December 2nd Public Meeting Comments and Responses

BWROG/NRC Meeting
Albuquerque, NM
February 23-24, 2016

Analysis Comments

Figure 5-49
STRAINER CONDITIONAL FAILURE PROBABILITY DIVIDED INTO FAILURES CAUSED BY EXCEEDANCE OF THE GE HEAD LOSS CORRELATION RANGE OF APPLICABILITY AND FAILURES CAUSED BY OTHER PHENOMENA FOR THE LBLOCA ABOVE TAF SCENARIO

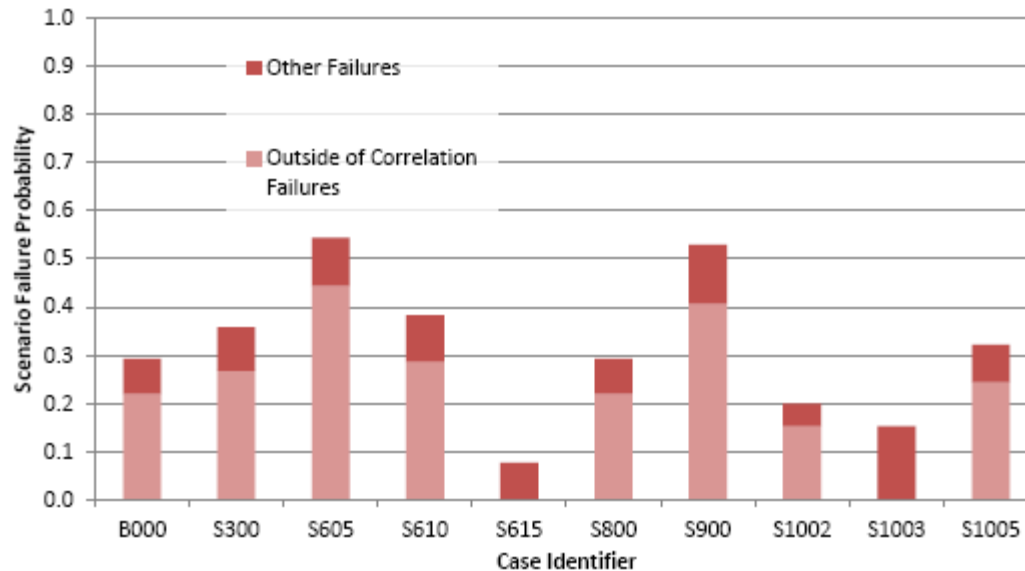
Comment: Determine how assigning scenarios outside of the bounds of the GE correlation to failure affects the conditional strainer failure probability results

Response: Results in the ECCS SS R-IS Phase II report provide failure attribution w.r.t. the GE correlation for applicable T-H cases. This comment is not applicable to Phase III since the GE correlation is not used for strainer head loss calculation.
